Project: E.L. Miller ES - Facility Improvements Project No: 354-35
 Contractor: Centennial Contractors Architect: CDH Architects
 Originator: Ryan Fernandez Date: April 10, 2024

**THE DEKALB COUNTY BOARD OF EDUCATION
CONSTRUCTION CONTRACT CHANGE ORDER**

Project Name:	E.L. Miller ES – Facility Improvements
Project No.:	354-423
Change Order No.:	03
Date:	April 3, 2024

E.L. Miller ES
Change Order No. #3 - Breakdown

SHEET NUMBER
M202

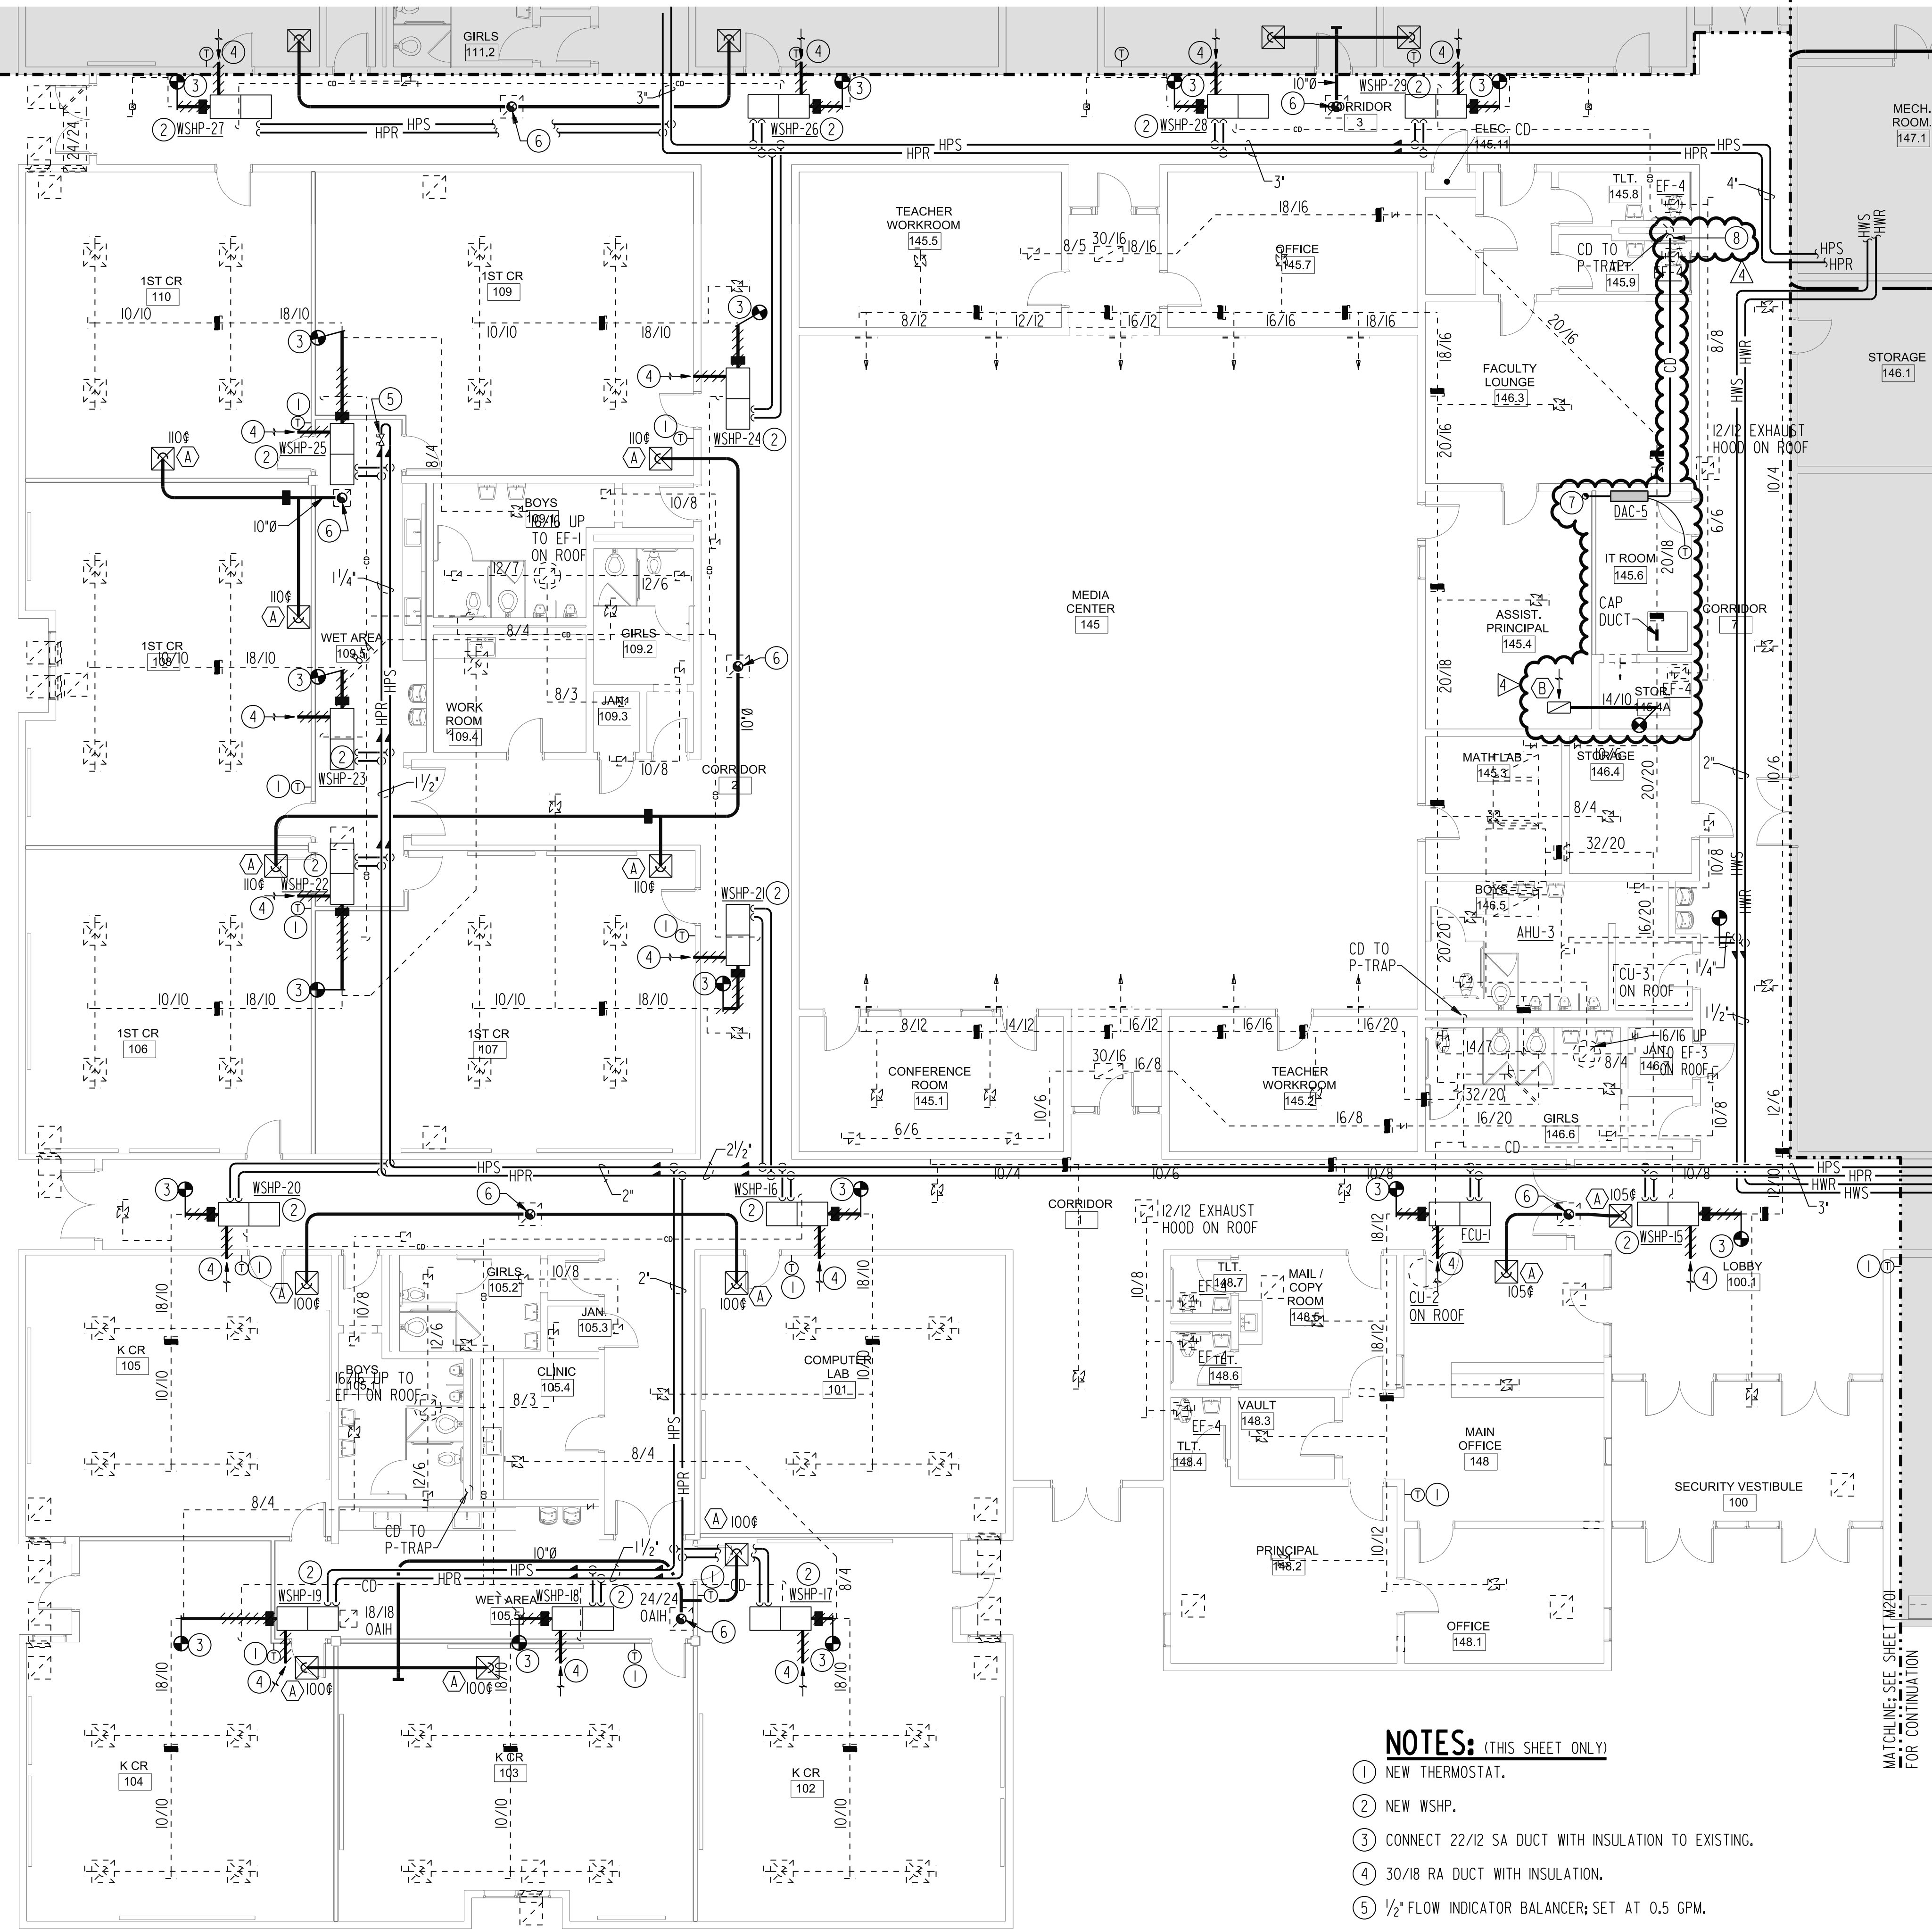
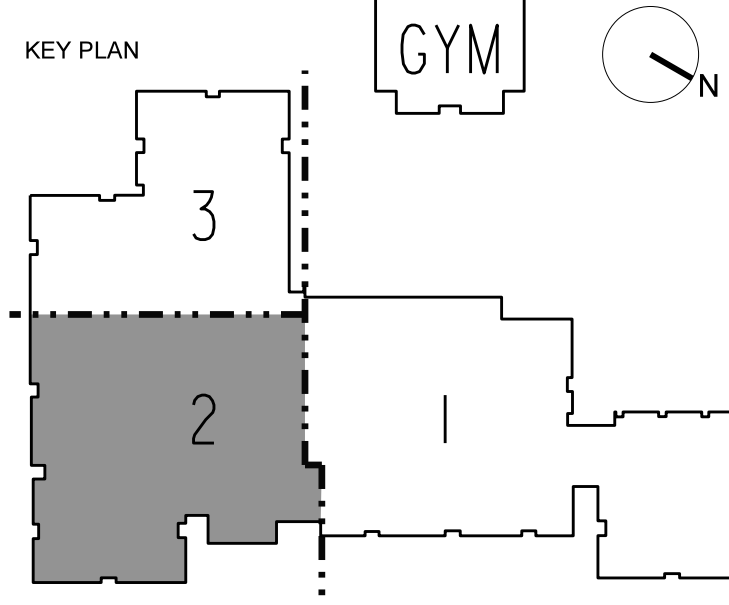
Separate room 145.4 and room 145.6 to create a separate IT Room for the DCSD IT rack based off drawings EL Miller IT Room Revision 4 provided by CDH Architecture. This includes a new ductless split system for Room 145.6, a new gypsum board partition to deck above, relocating fire suppression is necessary, along with incidental painting and flooring repairs. Reference RFI #49 and drawings E.L. Miller IT Room Renovations 4 that are attached.

12/04/2023	
4	REV 6 IT ROOM

SHEET NUMBER
MD202

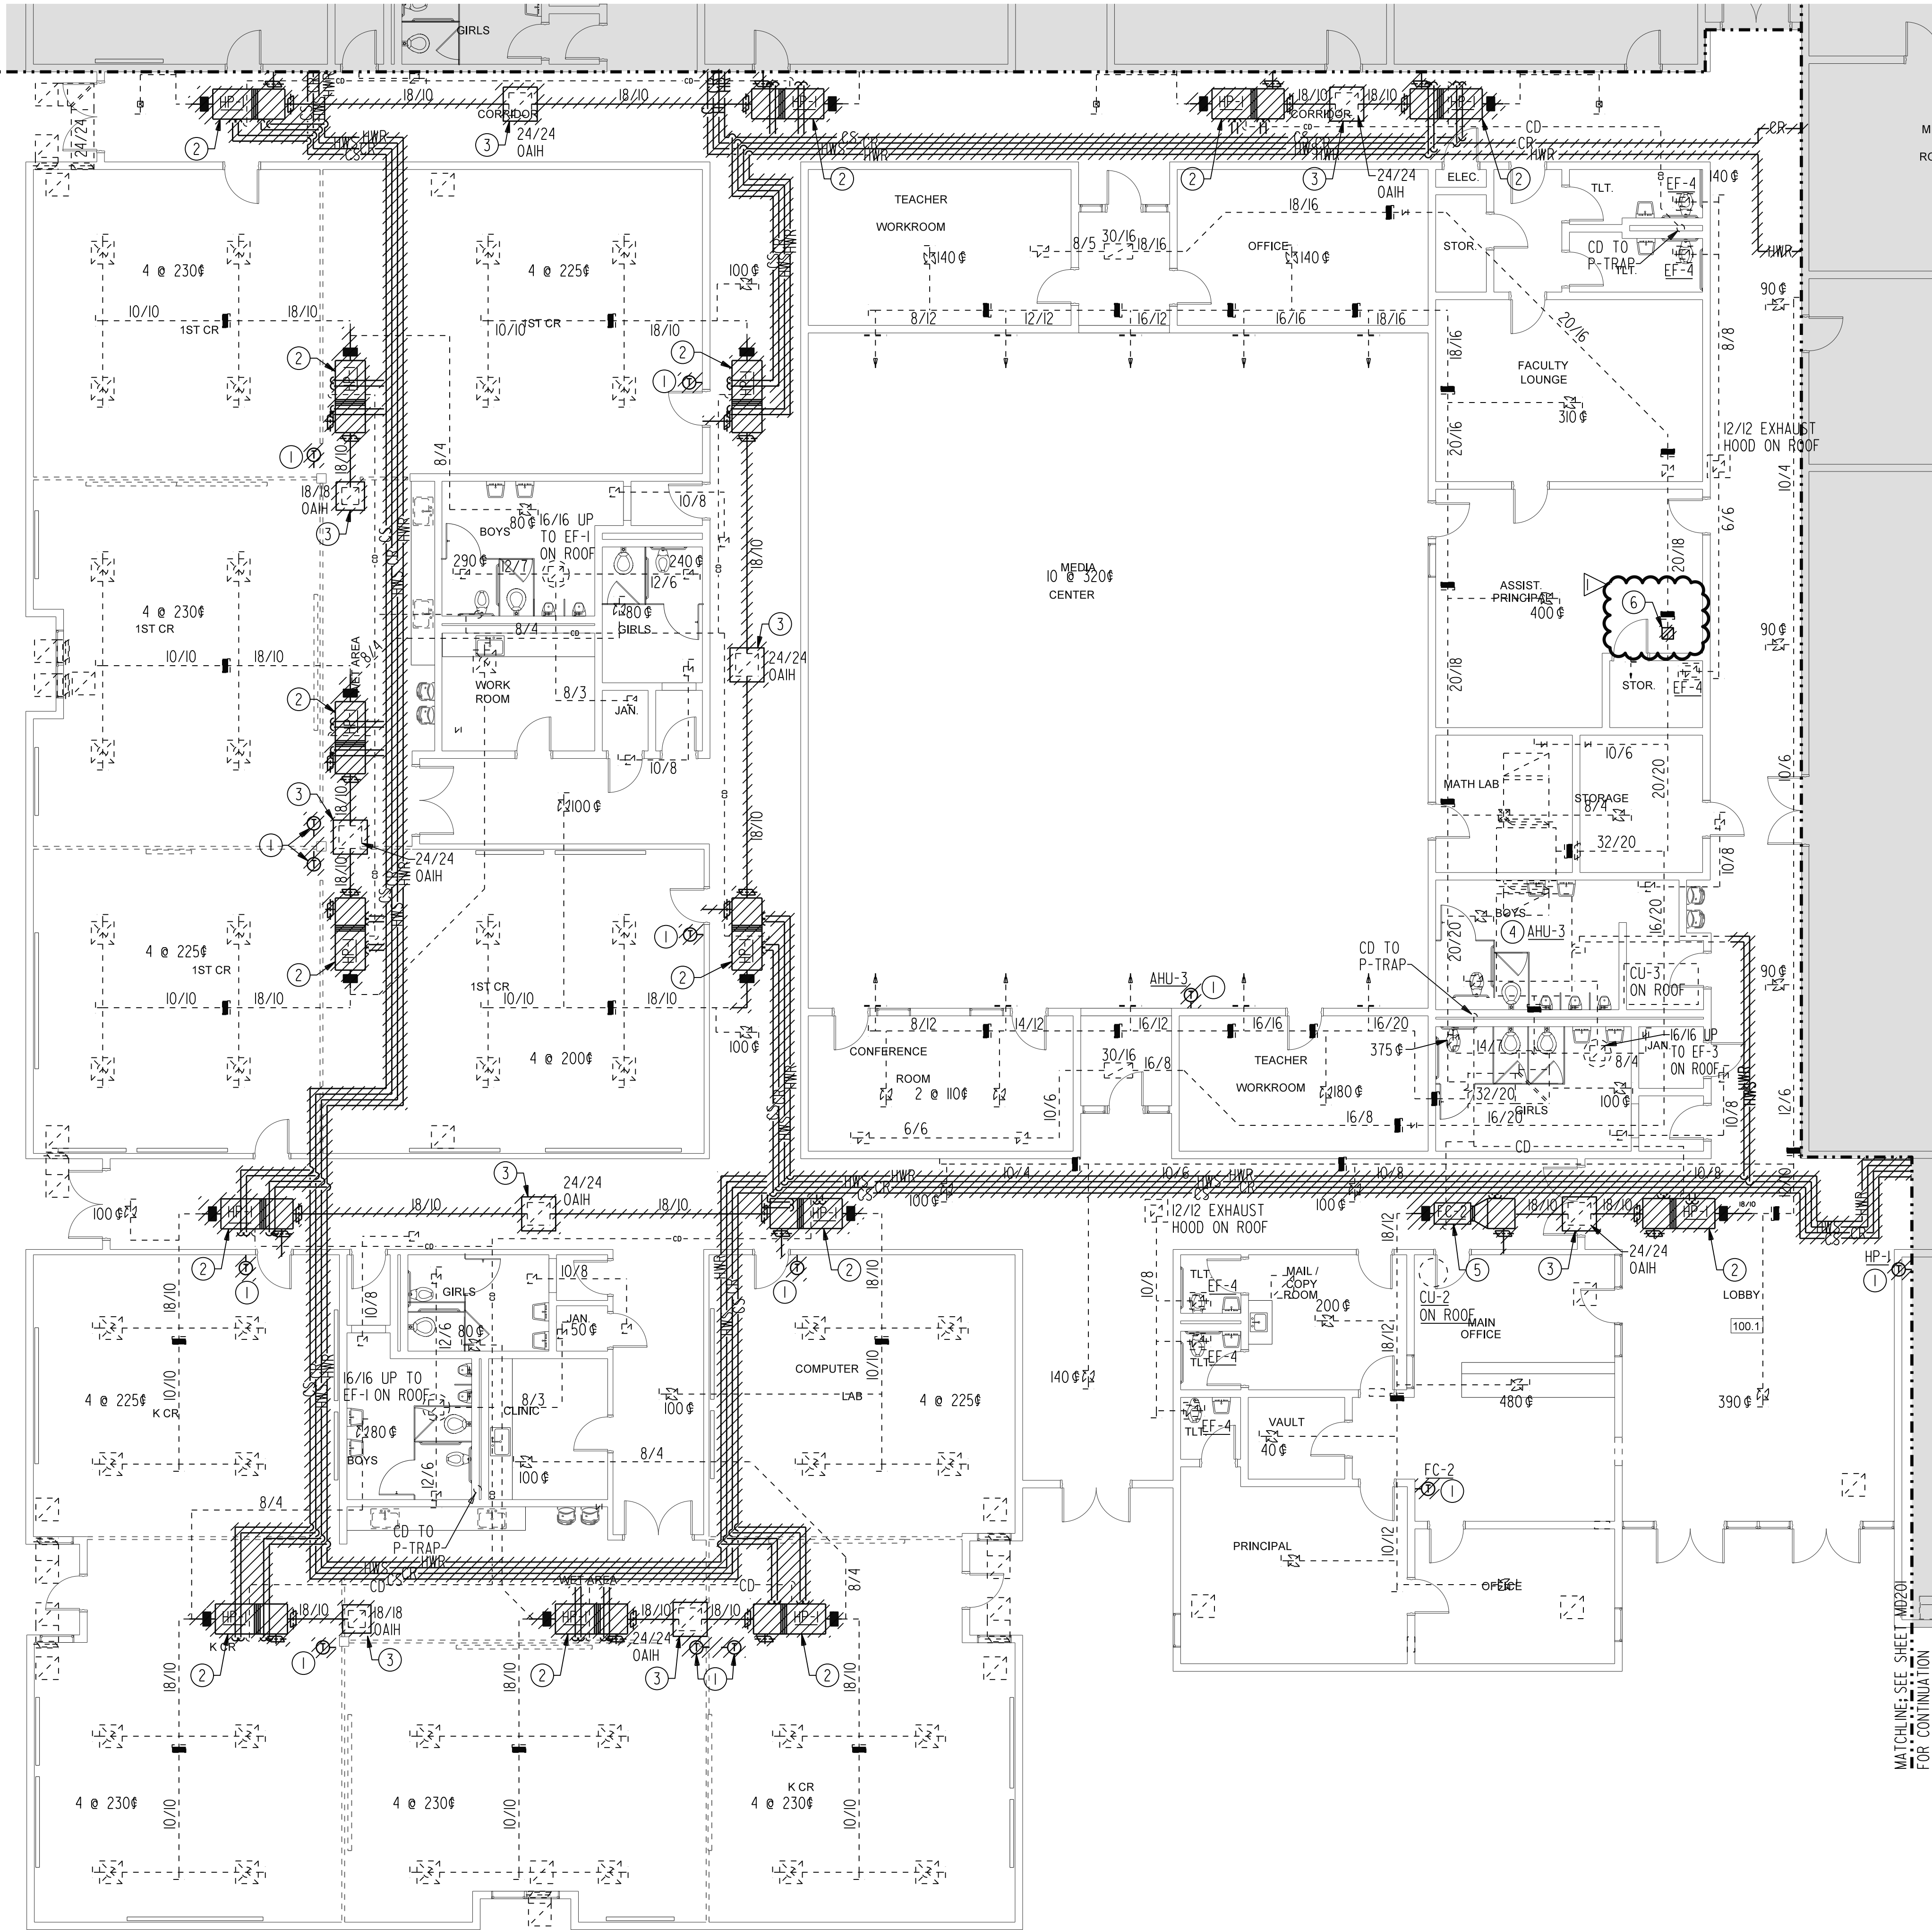
12-04-2023	
4 REV 6 IT ROOM
